REMARKS

Reconsideration of the above-identified application is respectfully requested.

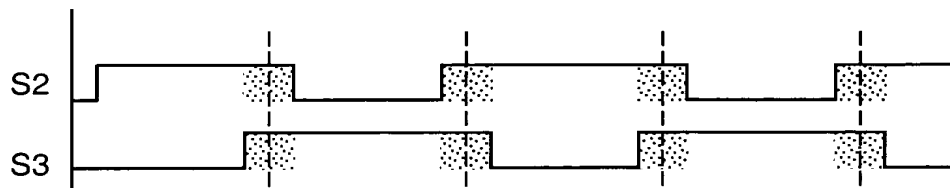
The claims were rejected as unpatentable over Jang et al. The claims now recite the timing illustrated in the following sketch, taken from FIG. 3 of applicant's specification. The intervals of simultaneous conduction are stippled.

An inspection of FIGS. 1(b), 2(b), 3(b), 7(b), and 7(c) of the Jang et al. patent shows that this timing is not disclosed or suggested.
